Tennessee Valley Authority, 1101 Market Street, Chattanooga, Tennessee 37402

Browns Ferry Nuclear Plant, Units 2 and 3
Facility Operating License Nos. DPR-52 and DPR-68
NRC Docket Nos. 50-260 and 50-296

Subject: Supplement to Technical Specification Change TS-429 – Deletion of Low Pressure Coolant Injection Motor-Generator Sets for Browns Ferry Nuclear Plant, Units 2 and 3

REVISED EVALUATION FOR TECHNICAL SPECIFICATION CHANGE TS-429
Deletion of Low Pressure Coolant Injection Motor-Generator Sets for
Browns Ferry Nuclear Plant, Units 2 and 3

Figure 2, Resulting Configuration of Portion of BFN, Unit 2, Electrical Distribution System Associated with Planned Change

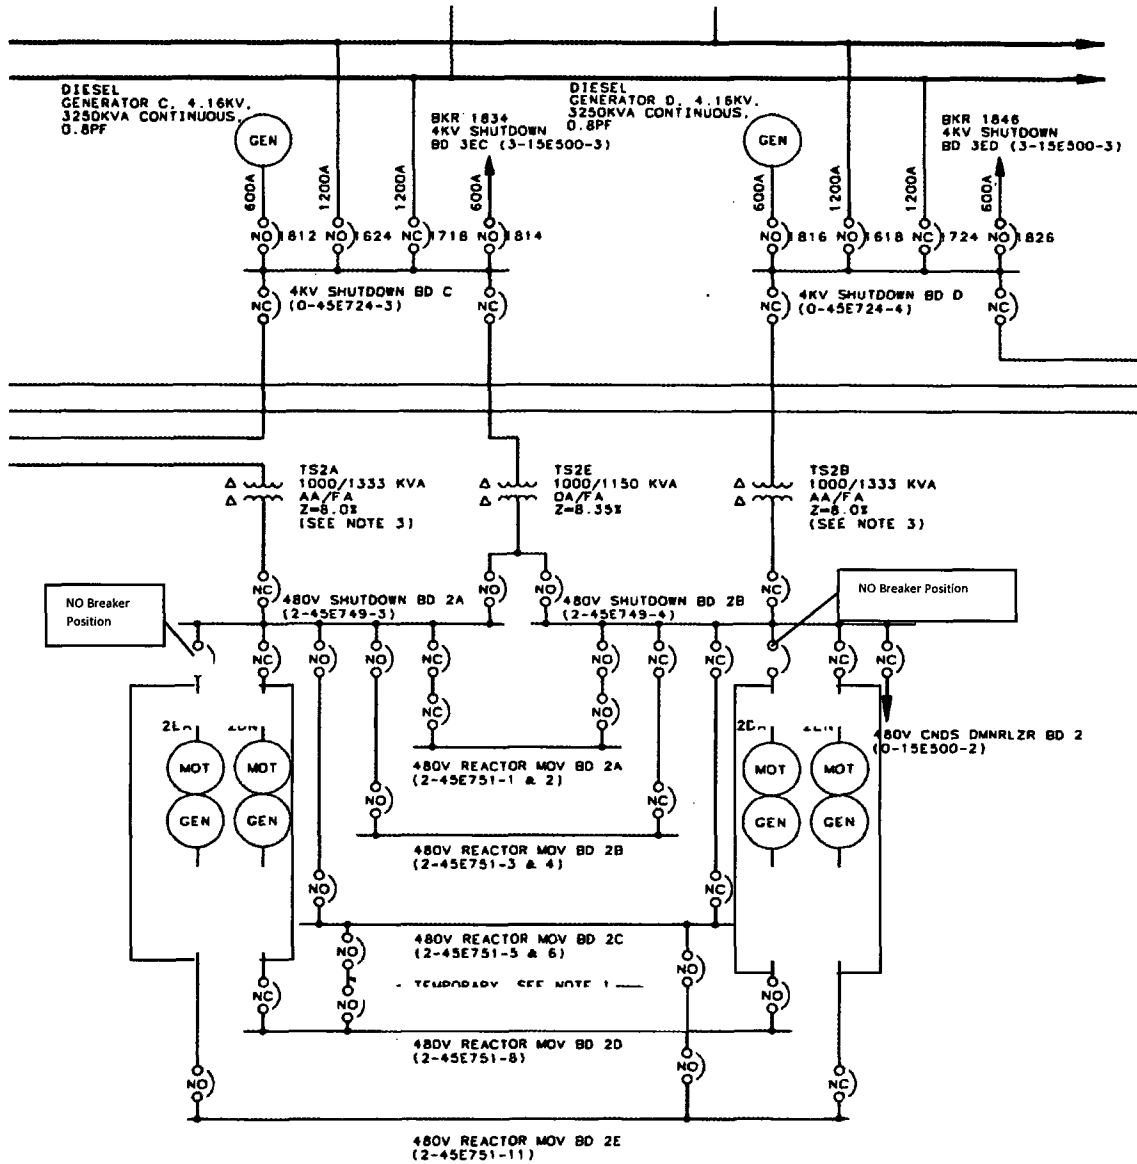
1. BFN, Units 2 and 3, LPCI MG Sets DN, DA, EN, and EA and their locally mounted instrumentation and controls will be removed from service and abandoned in place.
2. Instead of RMOV Boards D and E being powered from the LPCI MG Sets, they will be powered directly from the corresponding 480V Shutdown Boards through their normal feeds.
3. The feeder breakers for 480V RMOV Boards D and E at the applicable 480V Shutdown Boards will be modified from electrically operated to mechanically operated.
4. The alternate feeder breakers for 480V RMOV Boards D and E at the applicable 480V Shutdown Boards will be changed from normally closed to normally open.

After the planned change, the resulting configuration of the portion of the electrical distribution system associated with this planned change will be as shown in Figures 2 and 4 for BFN, Units 2 and 3, respectively.

Figure 3, Current Configuration of Portion of BFN, Unit 3, Electrical Distribution System Associated with Planned Change

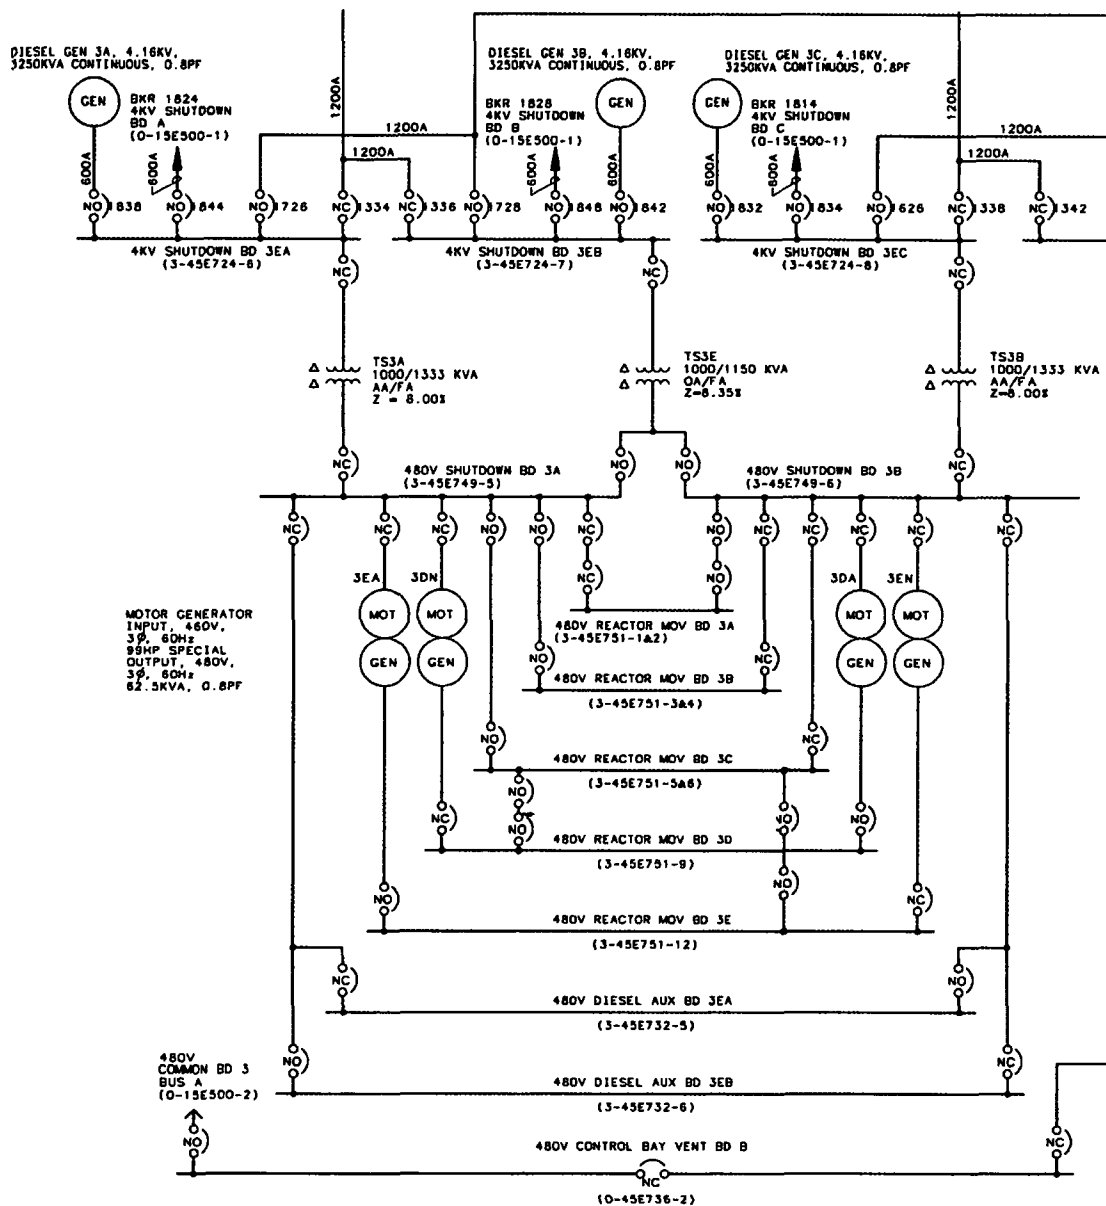
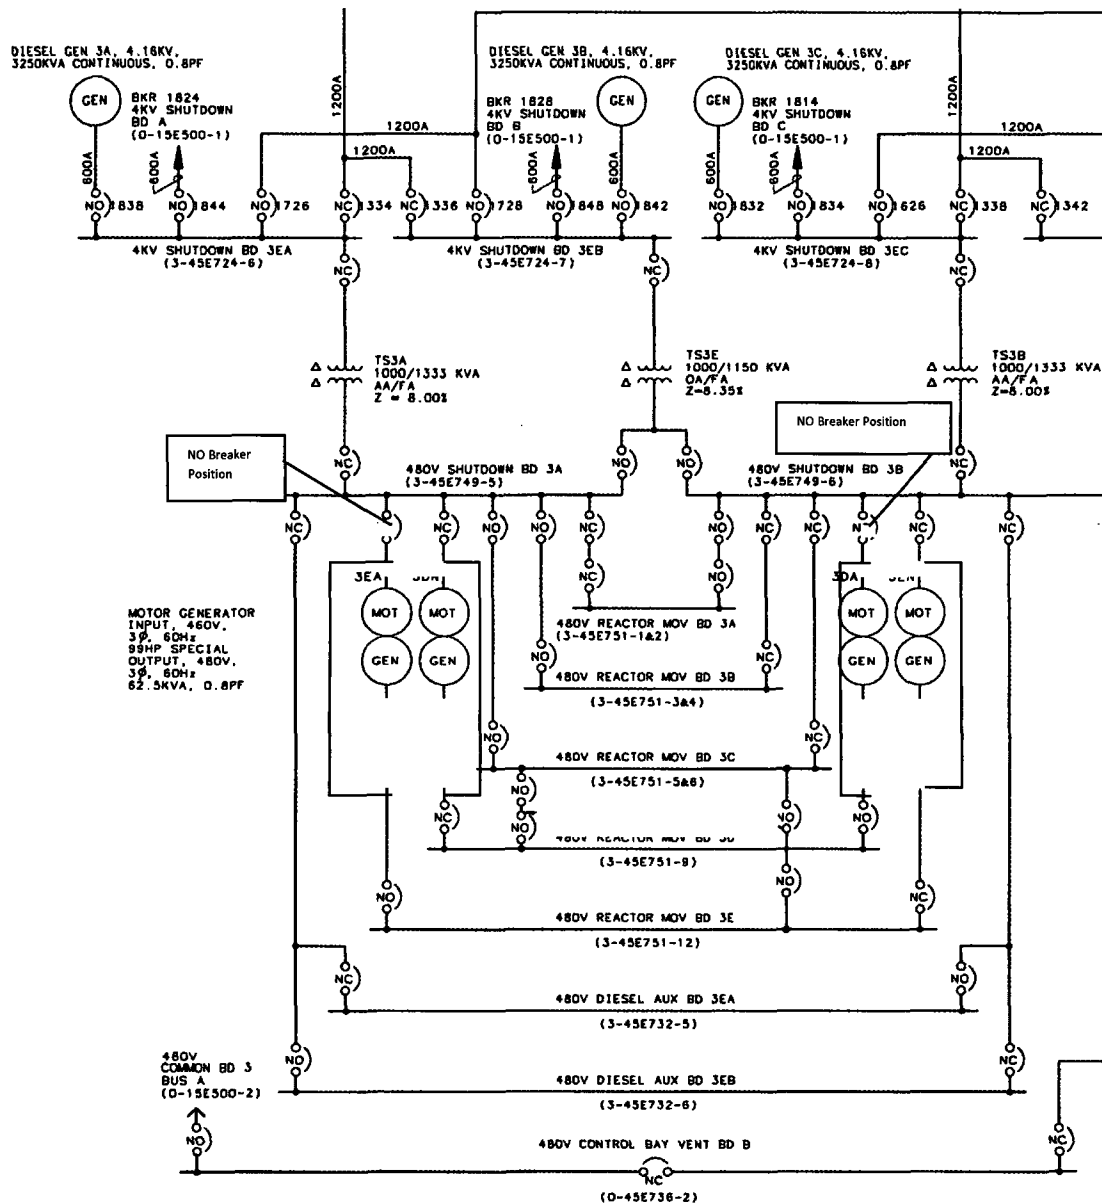
The current configuration of the portion of the electrical distribution system associated with this planned change is shown in Figures 1 and 3 for BFN, Units 2 and 3, respectively.
